DART SERVICE INSTRUCTION

TO AMEND OWNER'S & OVERHAUL PROCEDURE MANUAL O&OPM-C2 REV. H OR LATER APPROVED REVISIONS O&OPM-C3 REV. N OR LATER APPROVED REVISIONS O&OPM-C10 REV. K OR LATER APPROVED REVISIONS O&OPM-C15 REV. G OR LATER APPROVED REVISIONS O&OPM-C45 REV. J OR LATER APPROVED REVISIONS O&OPM-C60 REV. H OR LATER APPROVED REVISIONS O&OPM-C250 REV. H OR LATER APPROVED REVISIONS

1.0 PURPOSE

FIGURE 2-2: REVISED ELECTRICAL INSTALLATION

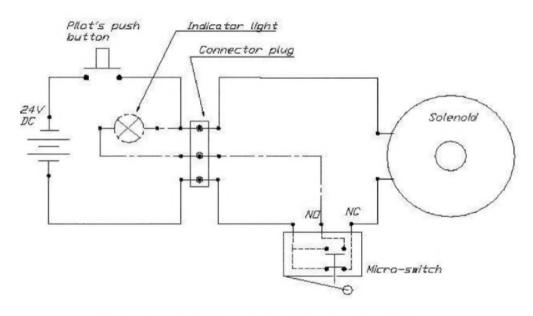
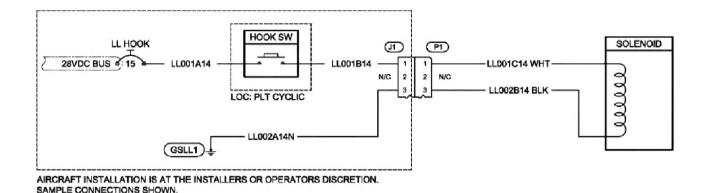
The micro-switch is no longer installed in new DART Remote Cargo Hooks. Figure 2-2 provides a revised electrical installation which includes an optional circuit breaker and removes the micro-switch installation.

The circuit breaker should be able to supply 15A intermittently to activate the solenoid. Dart recommends the following circuit breakers: MS14105-15, MS22073-15, MS24510-A-15, MS25244-15, and MS26574-15.

Per AC43.13-1B Chg. 1 (Ref. 1) Table 11-3 a 15A circuit breaker requires, at minimum, a 16 AWG wire. DART recommends the following wires as replacements: M22759/16-16-X and M22759/34-16-X.

Based on the stated maximum current drawing found in the aforementioned O&OPMs the hook switch should be capable of switching approximately 15A. Dart recommends the MS24523 switch. alternatively, a relay can be installed to switch the load to the cargo hook and a lower rated switch(es) may be used. Ensure the switch(es) and relays are appropriately rated for the required current draw.

Many aircrafts do not utilize guarded switches and controls for the cargo hook release and some installations utilize switches that only require slight pressure to actuate. This may lead to accidental cargo hook release during external load operations. Dart recommends the installation of a switch guard or dual switch installation to prevent inadvertent release of the cargo hook load.
